COMMITTEE OF THE WHOLE NOVEMBER 3, 2008

**ZONING BY-LAW AMENDMENT FILE Z.05.057
DRAFT PLAN OF SUBDIVISION FILE 19T-05V10
LAKE RIVERS INC.**

Red-Lined Revised Plan of Subdivision 19T-05V10

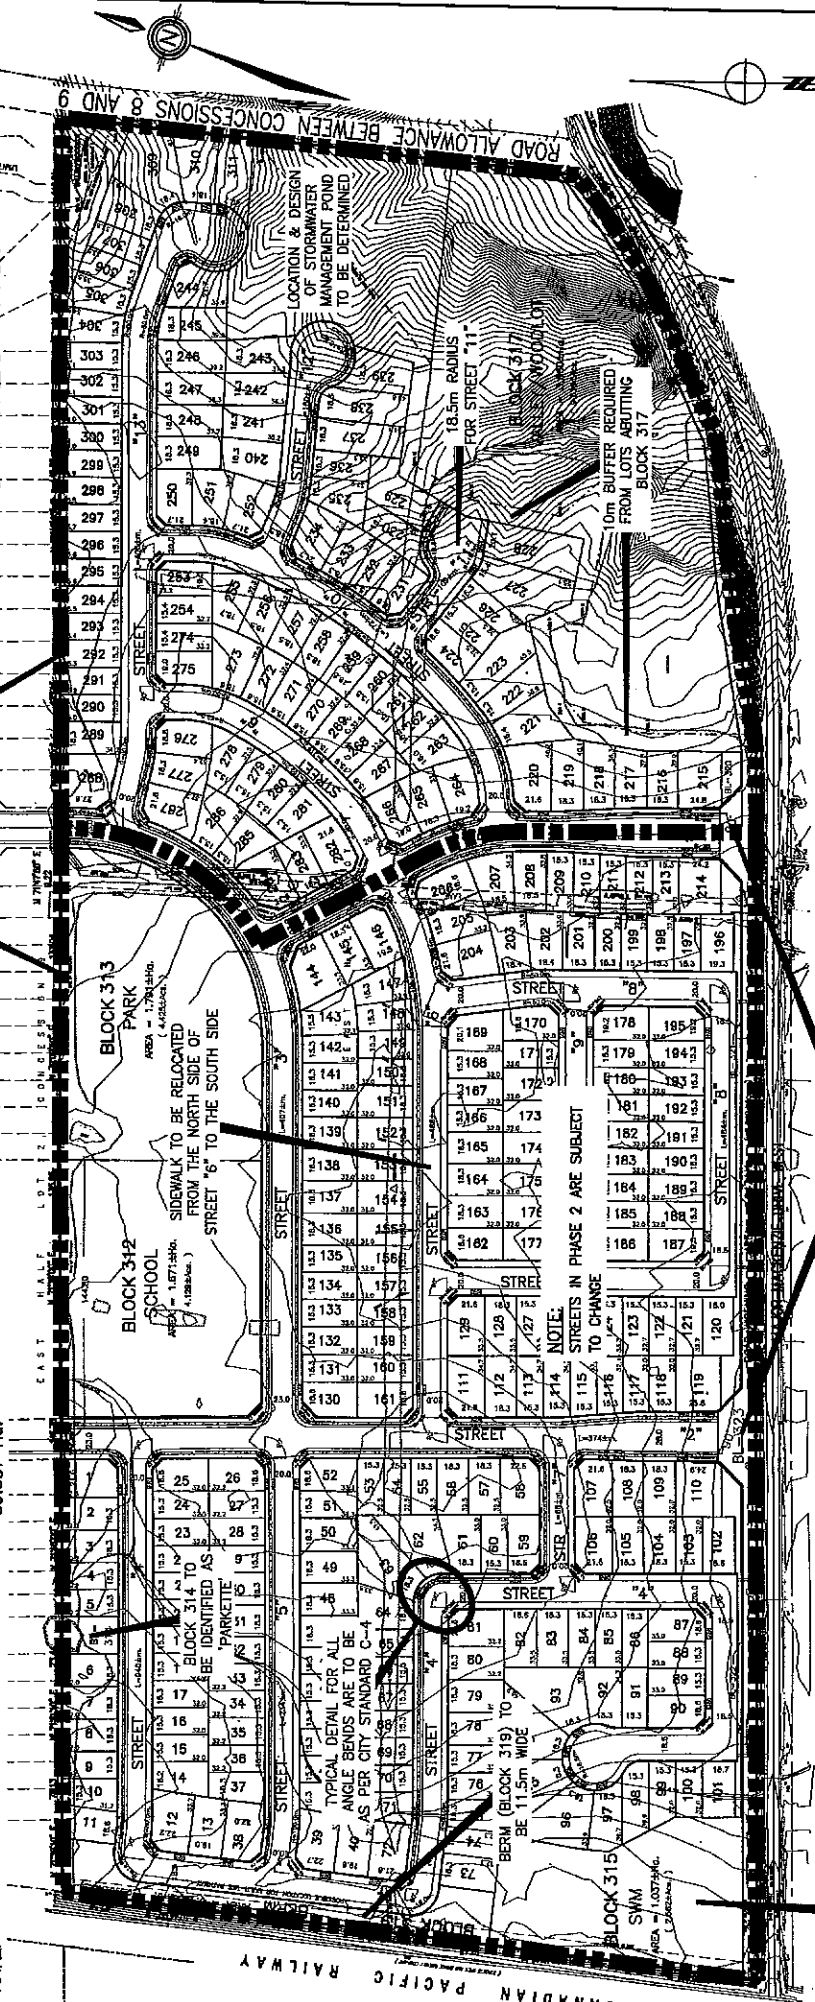
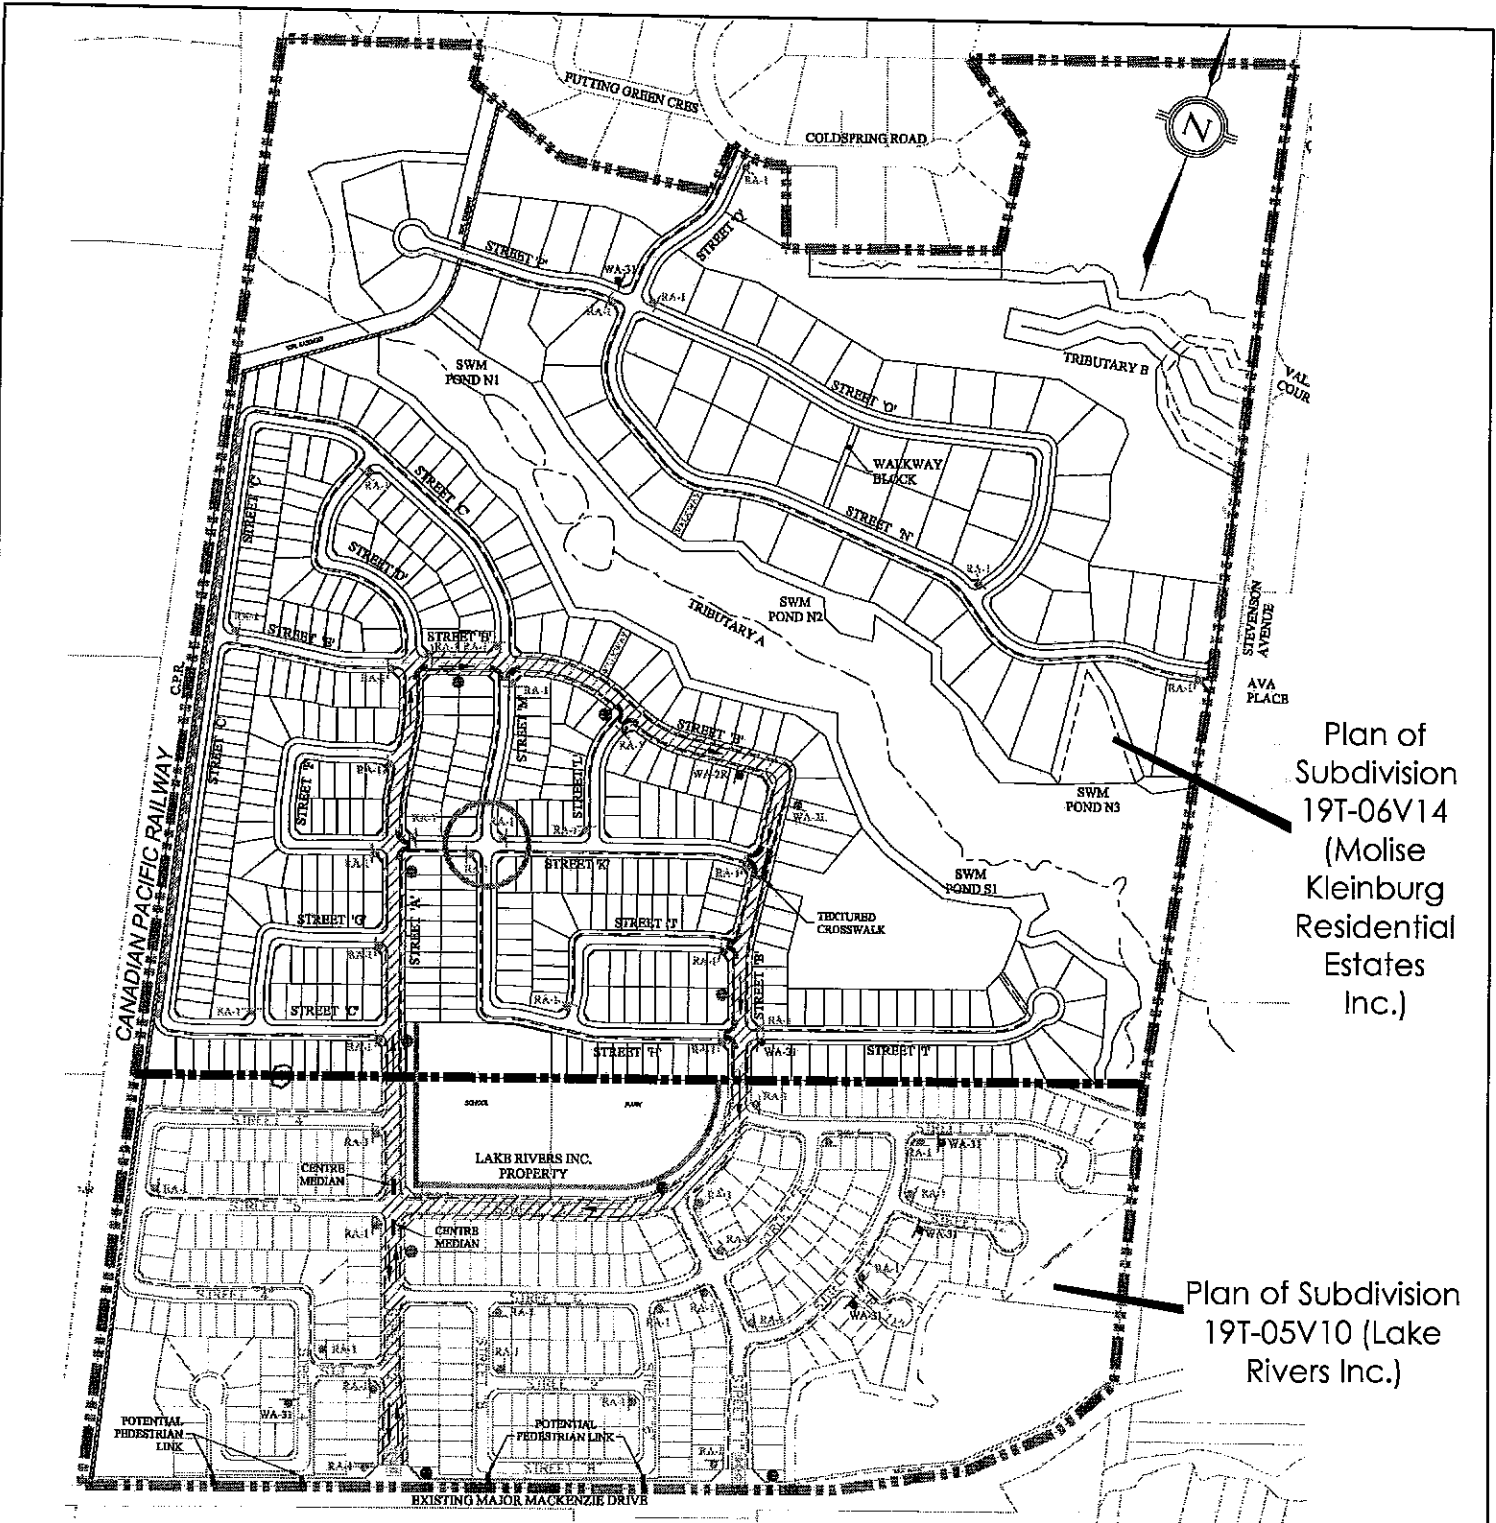
The Development Planning Department has reviewed the proposal and requires the following red-lined revisions to the proposed draft plan of subdivision, as shown on Attachment #3:

- v) the berm (Block 319) is to be a minimum of 11.5 m in width;
- vi) the typical detail for all angle bends are to be as per "City Standard C-4";
- vii) the radius for Street "11" is to be 18.5 m;

- ix) the Owner shall convey land external to the plan for the proposed sanitary pumping station, east of Highway 27, free of all costs and encumbrances, prior to final approval of the plan;

- xii) the draft plan shall identify Block 314 as a "Parkette"; and,
- xiii) the telecommunication and hydro utility buildings/easements shall be identified on the draft plan.

1. The Plan shall relate to the Draft Plan of Subdivision, prepared by KLM Planning Partners Inc., dated October 15, 2008, incorporating red-line revisions as follows:

- v) the berm (Block 319) is to be a minimum of 11.5 m in width;
- vi) the typical detail for all angle bends are to be as per "City Standard C-4";
- vii) the radius for Street "11" is to be 18.5 m;

- ix) the Owner shall convey land external to the Plan for the proposed sanitary pumping station, east of Highway 27, free of all costs and encumbrances, prior to final approval of the Plan;

- xii) the draft plan shall identify Block 314 as a "Parkette"; and,
- xiii) the telecommunication and hydro utility buildings/easements shall be identified on the draft plan.
